**6. COA-047054-2019**

**Commission of  
Architectural Review**

**STAFF REPORT**

**Construct a rear addition and deck.**

Figure 1. Rear elevation, 1987

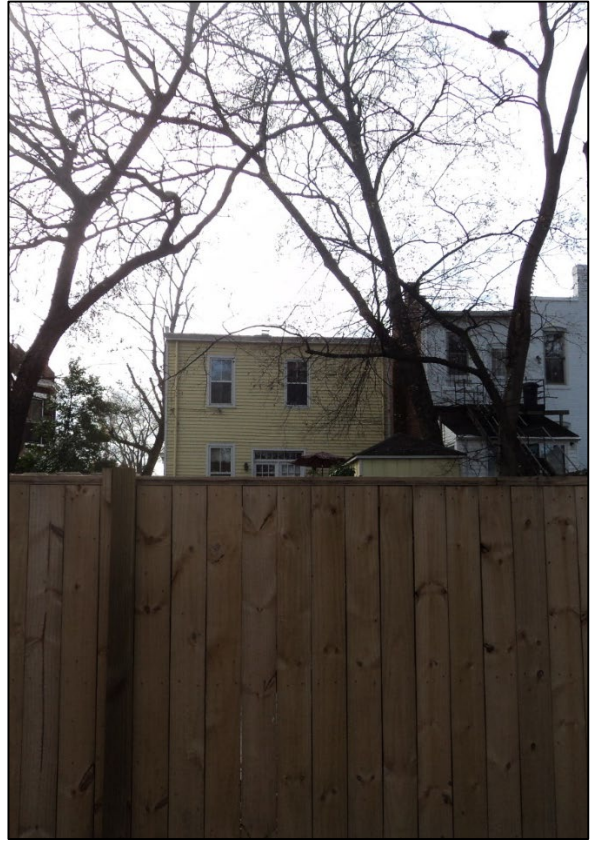
Materials, #1, p. 47     *Additions should not obscure or destroy original architectural elements.*     The rear elevation of the home has been altered by previous owners. Staff has also located photographic documentation which suggests that little historic fabric remains at the rear of the home (see Figure 1).
